**PUENTE HILLS**

**INTERMODAL**

**FACILITY**

**FINAL EIR**

Aerial Photograph

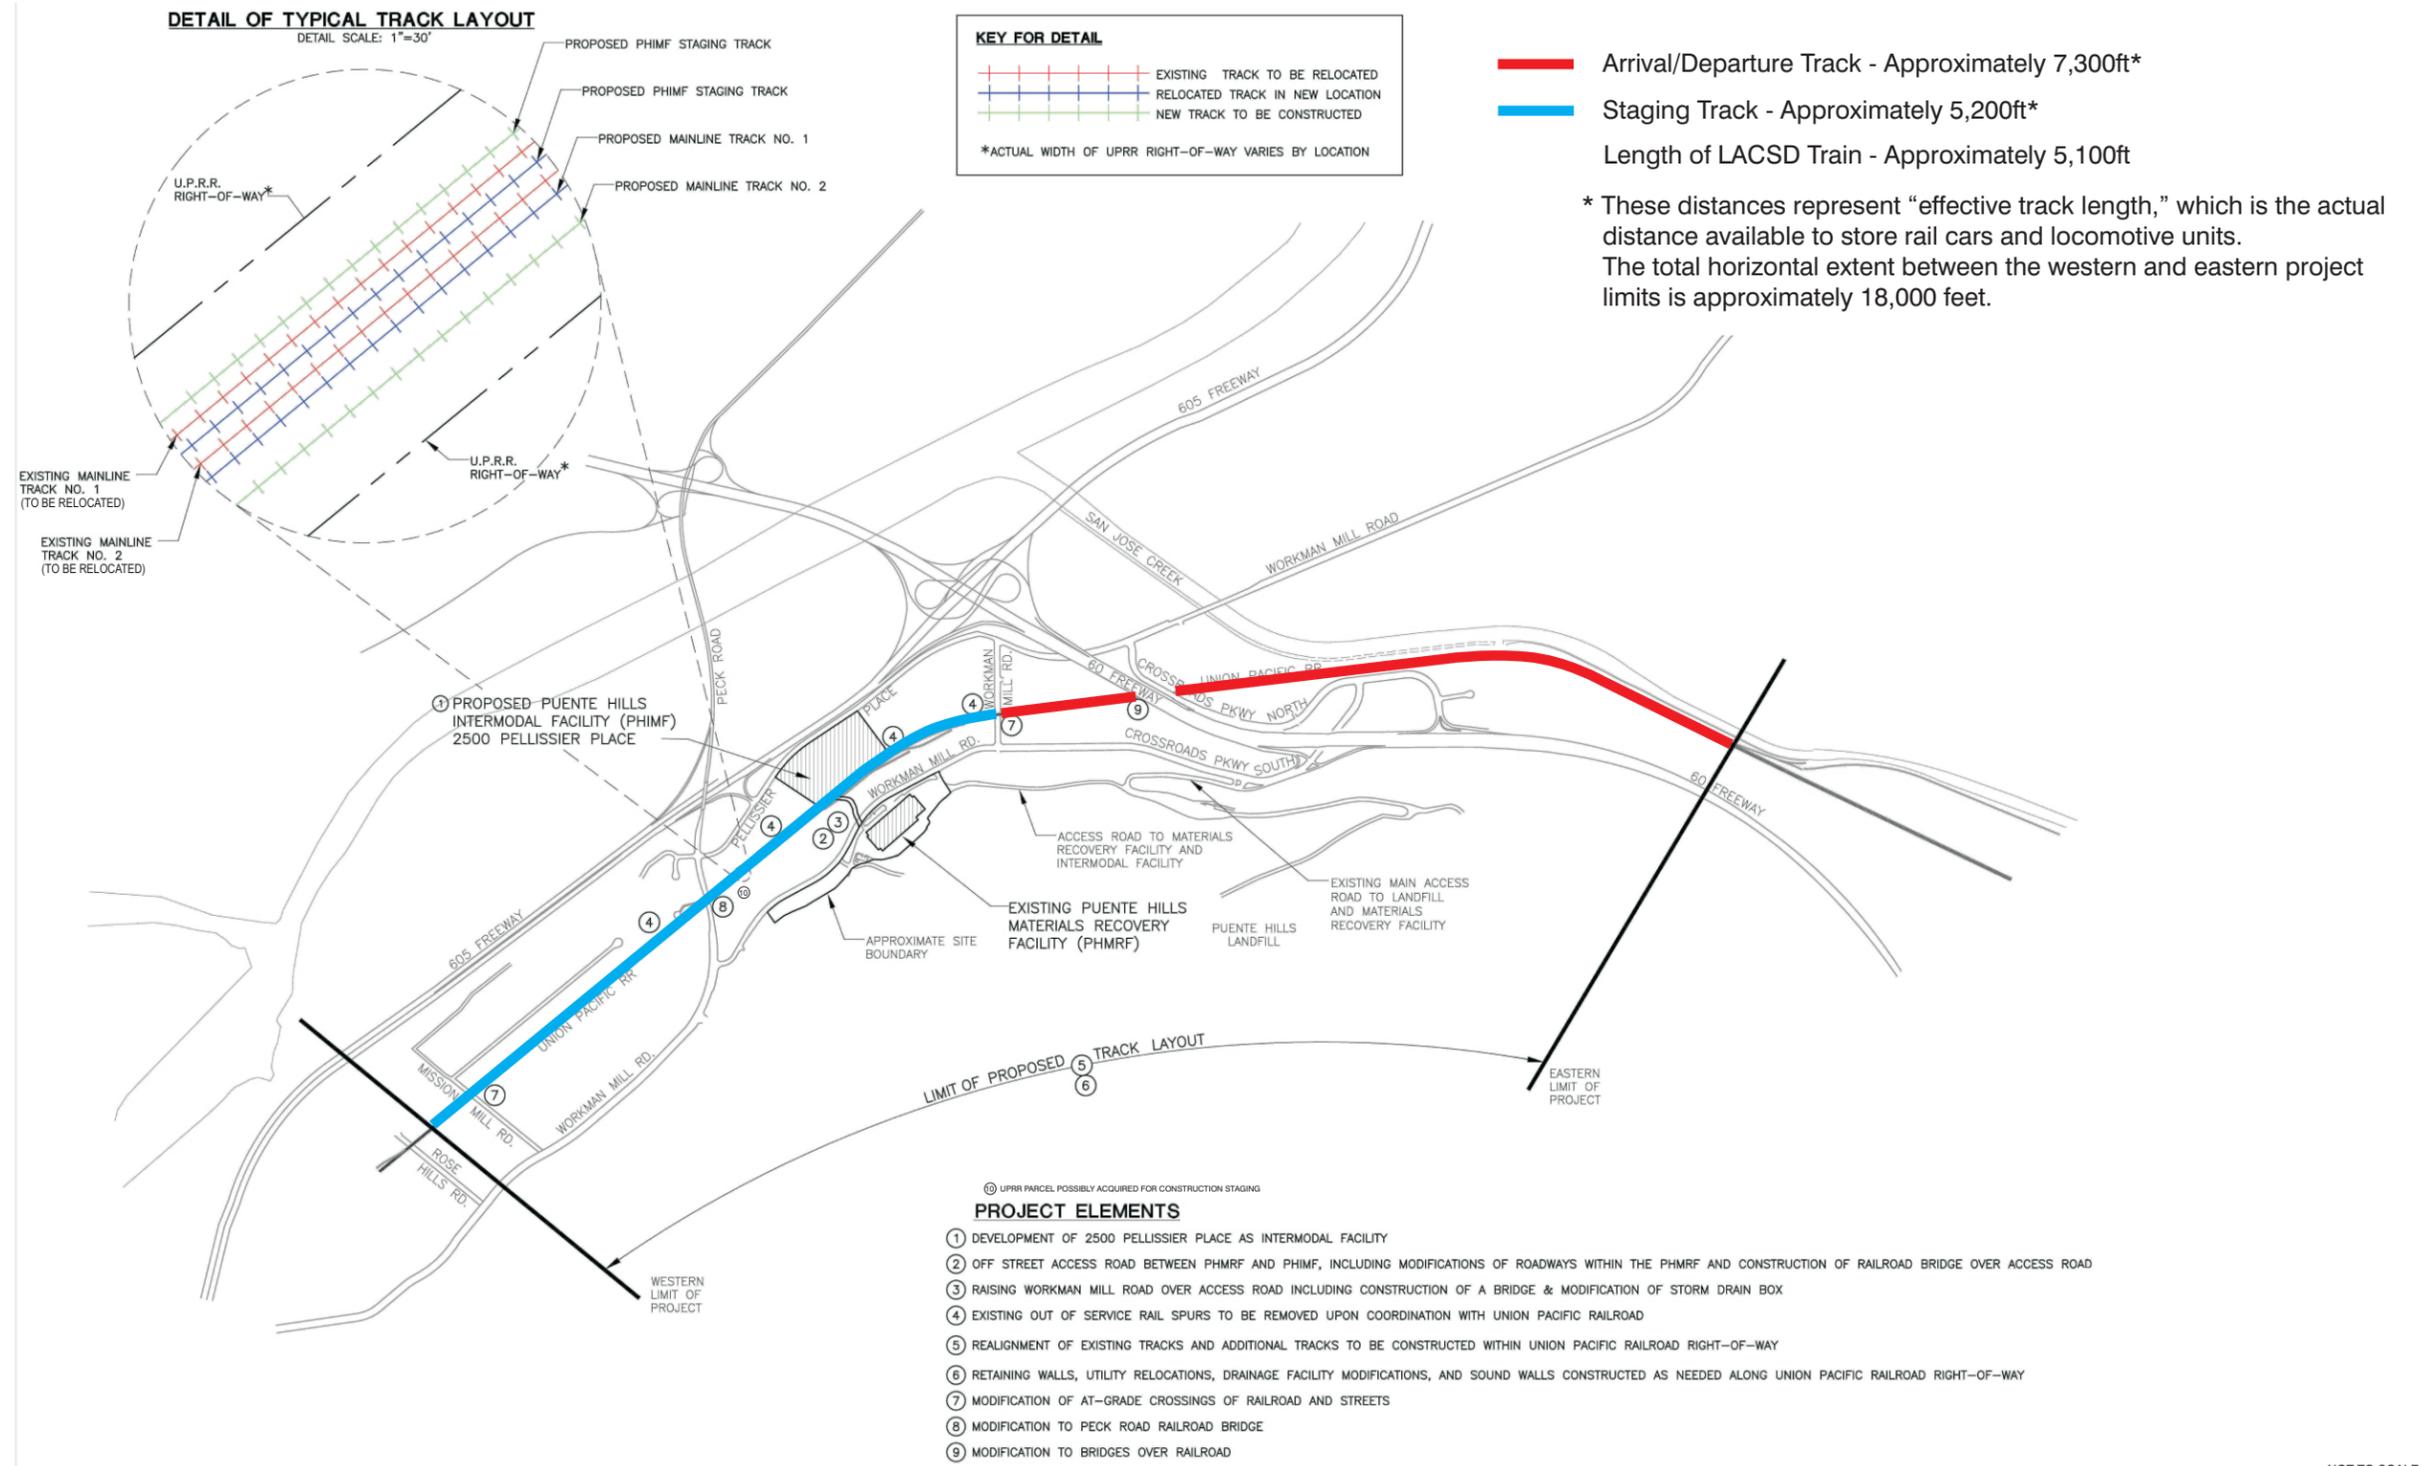
**A scale has been incorporated on the following figures in response to Comments D11-4, D11-29, E1-18, from Maria Mejia, Attorney:**

- Figures 1-2 and 3-3, *Aerial Photograph*
- Figure 1-6 and 7-1, *Location of Project Alternatives*
- Figure 4-1, *Sensitive Land Uses Proximate to the Project Site*
- Figure 5.1-2, *Viewshed Location Map*
- Figure 5.2-2, *Predominant Wind Directions*
- Figure 5.7-1, *Noise and Vibration Monitoring Locations*
- Figure 5.7-8, *Sound Wall Locations*

## Track Layout

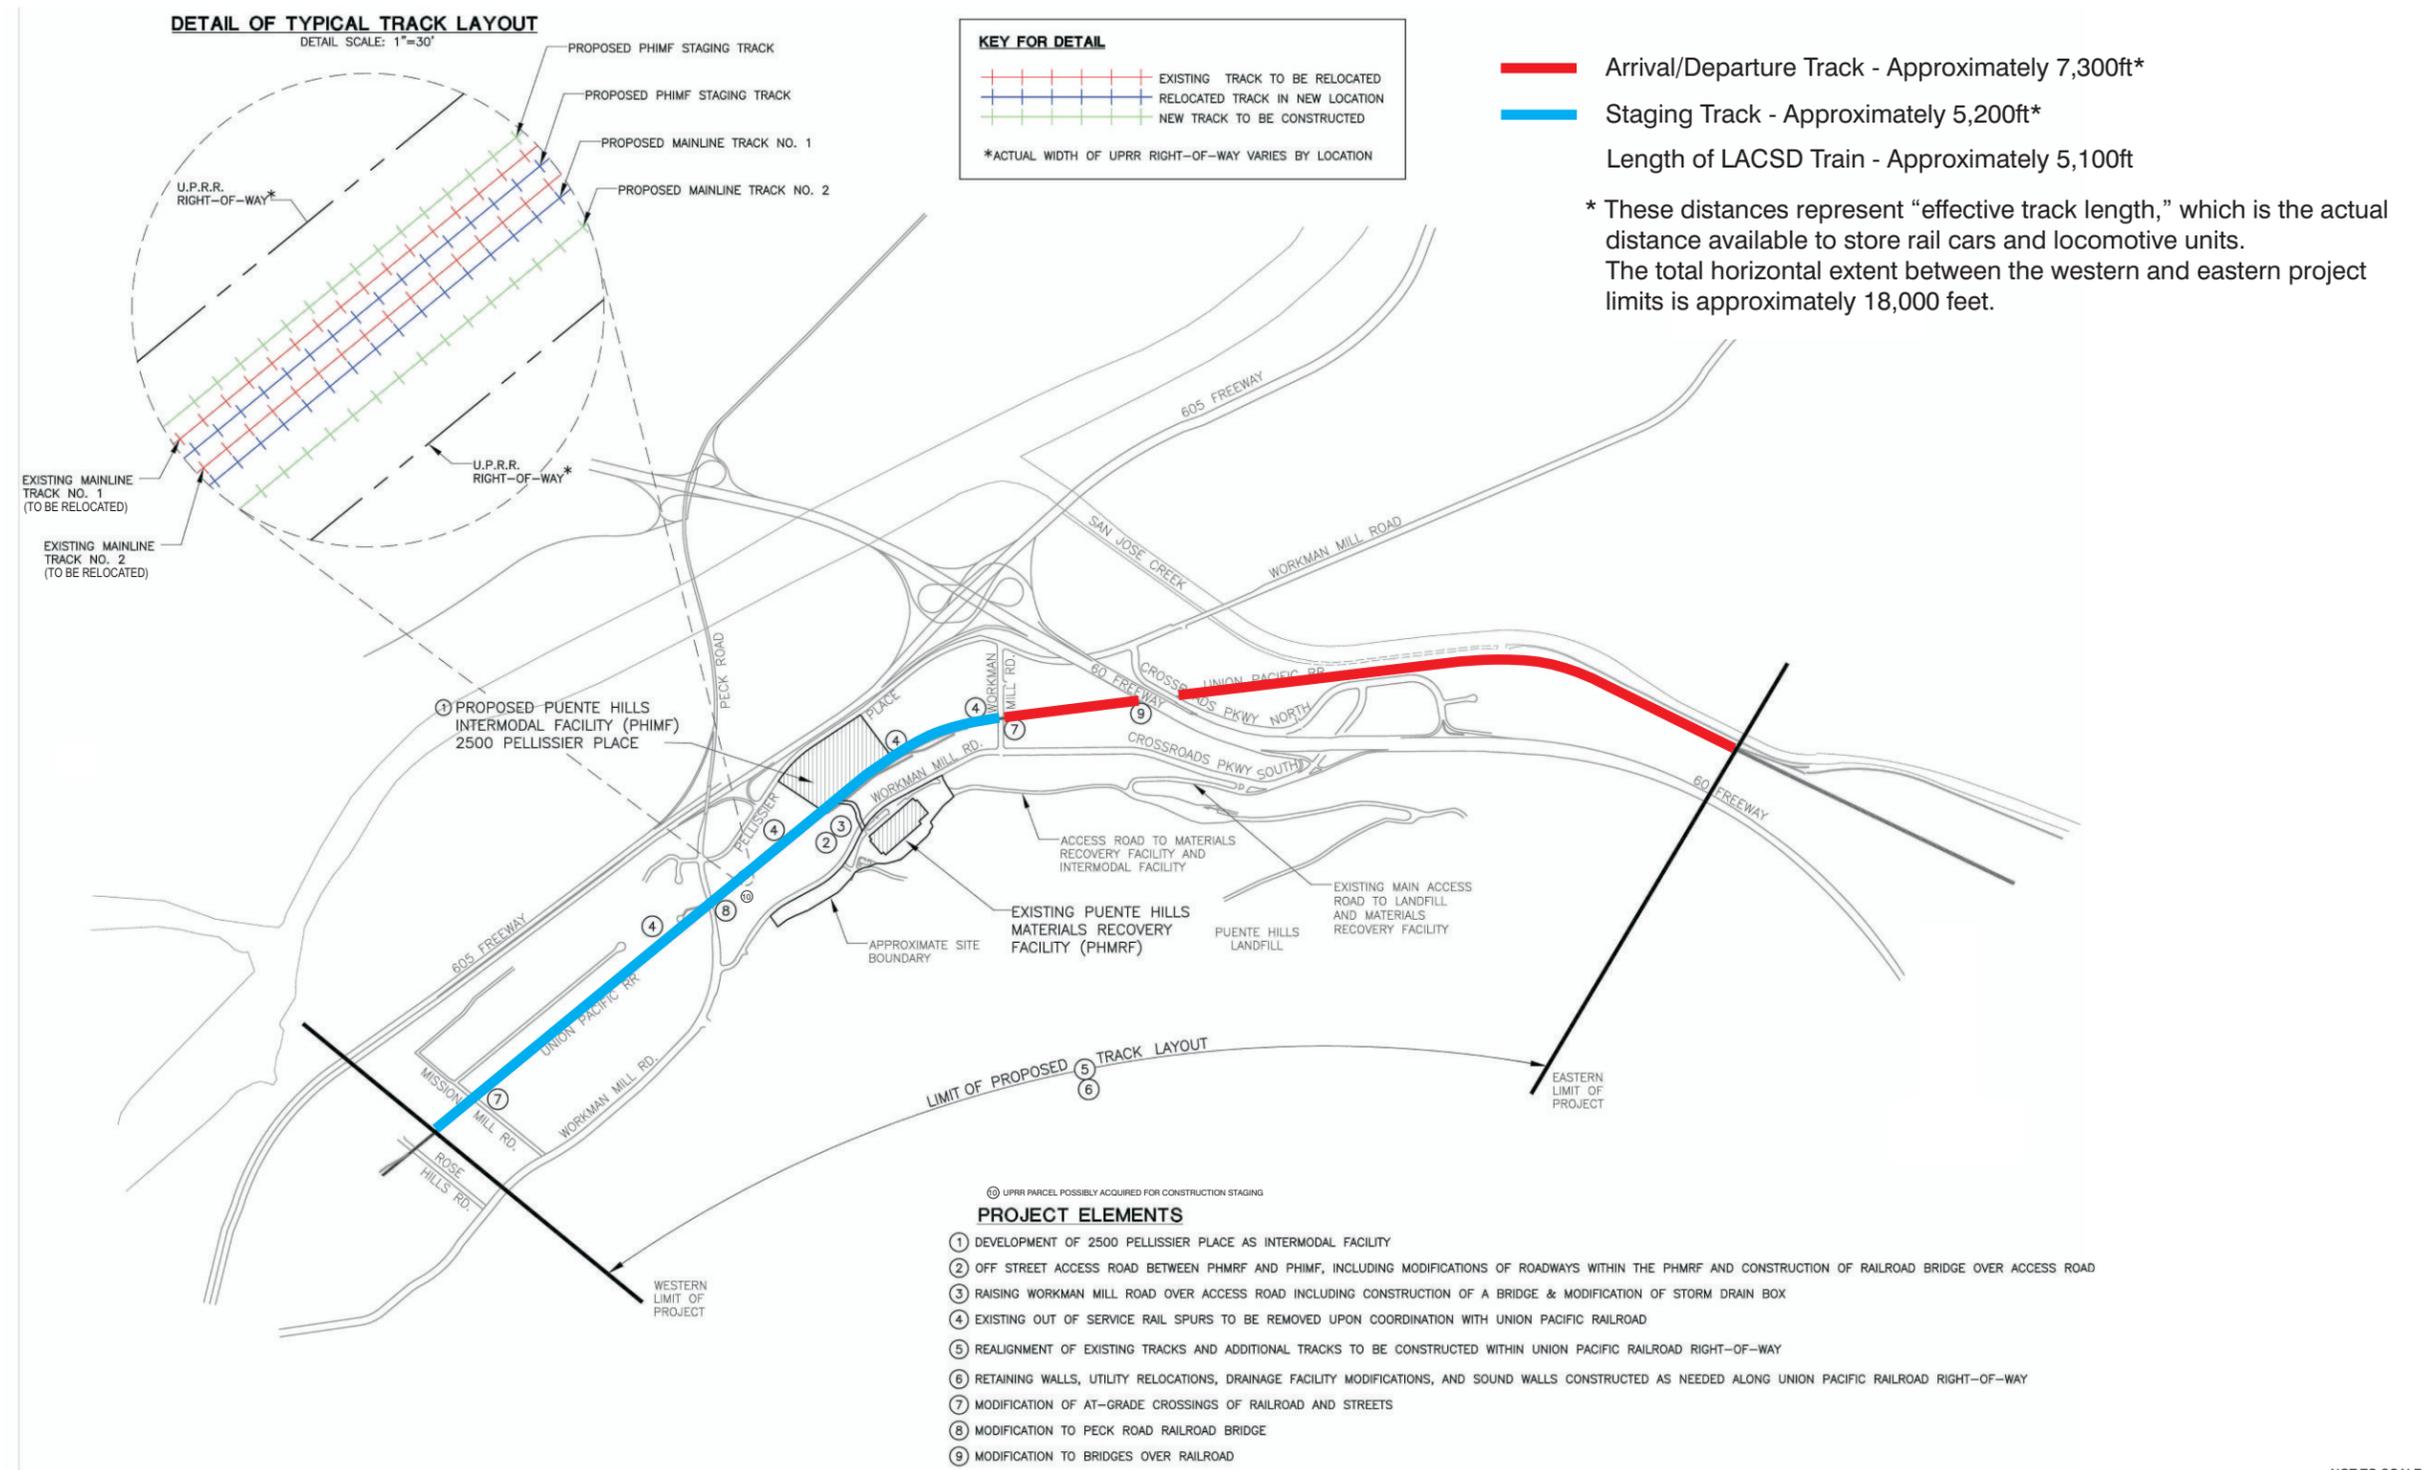
**The description of the length of the staging and arrival/departure tracks has been revised in the following figures:**

- Figure 1-4 and 3-12, *Track Layout*

Sound Wall Locations

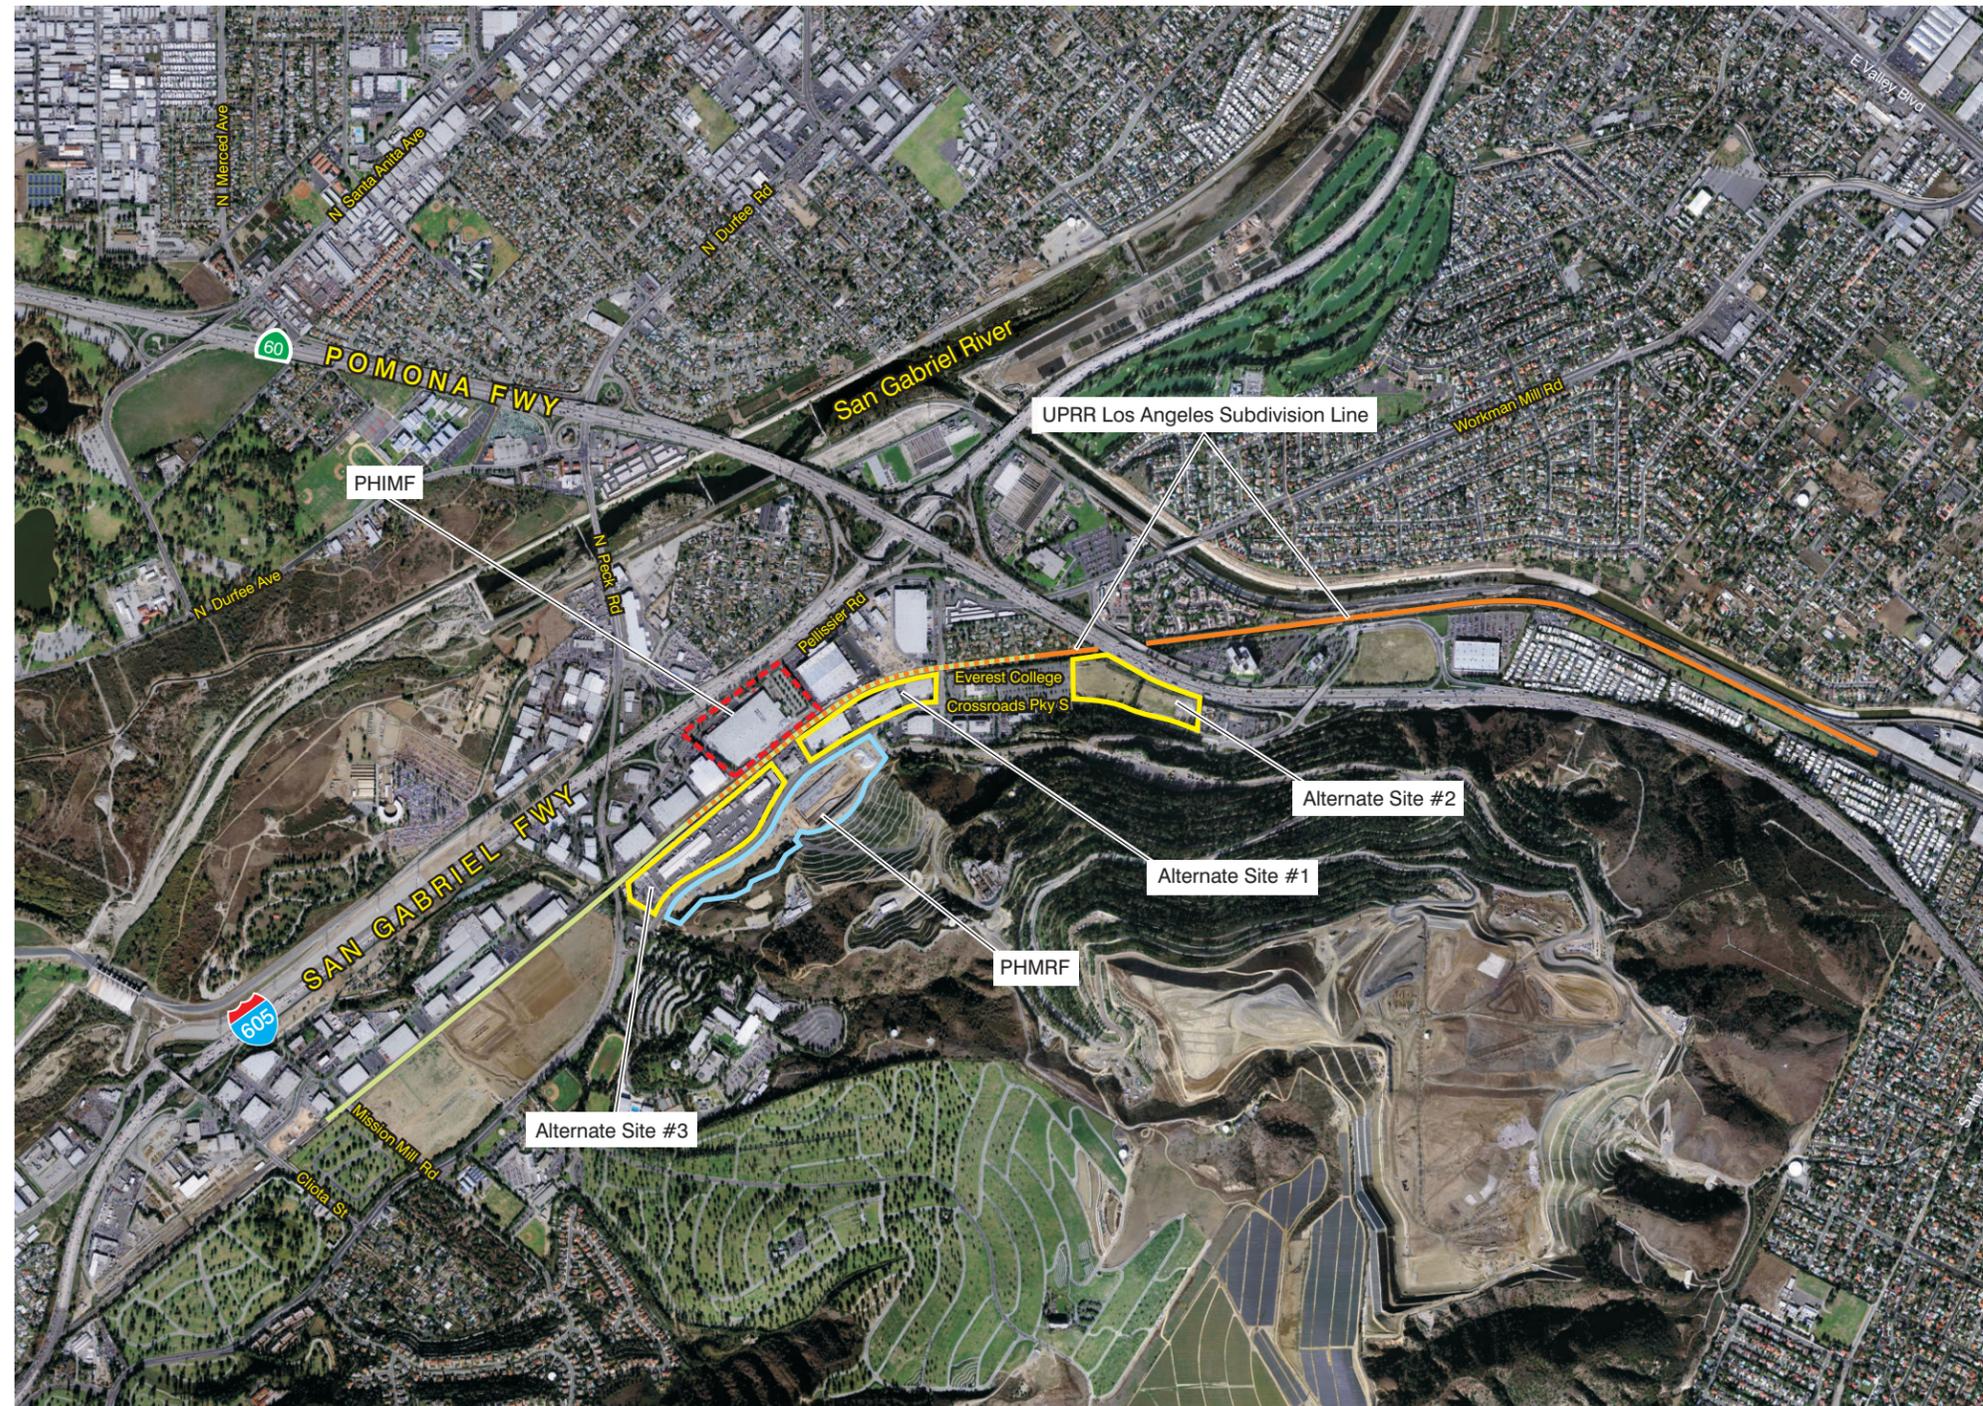
- Sixteen-foot sound walls installed along the UPRR right-of-way adjacent to the Gladstone residences and the Whittier Woods residences, as shown on Figure 5.7-8.
- Upgraded windows and doors, with a minimum Sound Transmission Class (STC)-rating of 25, for the first and second row of noise-sensitive uses facing the LACSD arrival/departure tracks and affected by project-related train noise.
